Project	IEEE 802.16 Broadband Wireless Access Working Group < http://ieee802.org/16 >	
Title	RS Sleep Mode	
Date Submitted	2007-1-8	
Source(s)	Kanchei (Ken) Loa, Hua-Chiang Yin, Yi-Hsueh Tsai, Shiann Tsong Sheu, Yung-Ting Lee, Youn-Tai Lee, Frank C.D. Tsai, Heng-Iang Hsu, Chih-Chiang Hsieh, Tien-Hsiang Lo Institute for Information Industry 8F, No. 218, Sec. 2, Dunhua S. Rd., Taipei City 106, Taiwan, ROC.	Voice: +886-2-27399616 Fax: +886-2-23782328 loa@nmi.iii.org.tw
Re:	IEEE802.16j-06/034: "Call for Technical Proposals regarding IEEE802.16j"	
Abstract	This contribution proposes procedures for RS sleep mode procedure.	
Purpose	Text proposal for 802.16j Baseline Document	
Notice	This document has been prepared to assist IEEE 802.16. It is offered as a basis for discussion and is not binding on the contributing individual(s) or organization(s). The material in this document is subject to change in form and content after further study. The contributor(s) reserve(s) the right to add, amend or withdraw material contained herein.

RS Sleep Mode

Figure D. 10--Example RS sleep mode — RS initiated

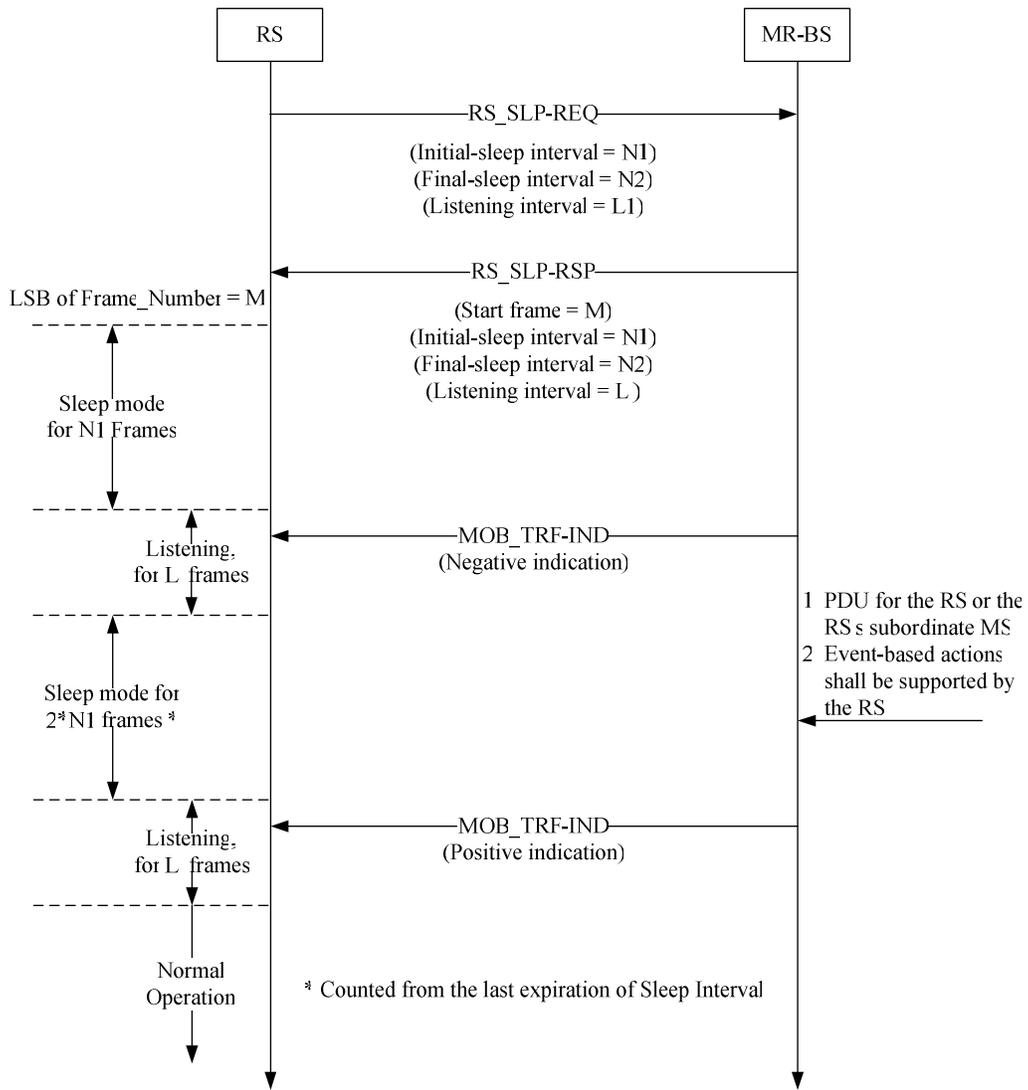
Insert new figures in annex D:
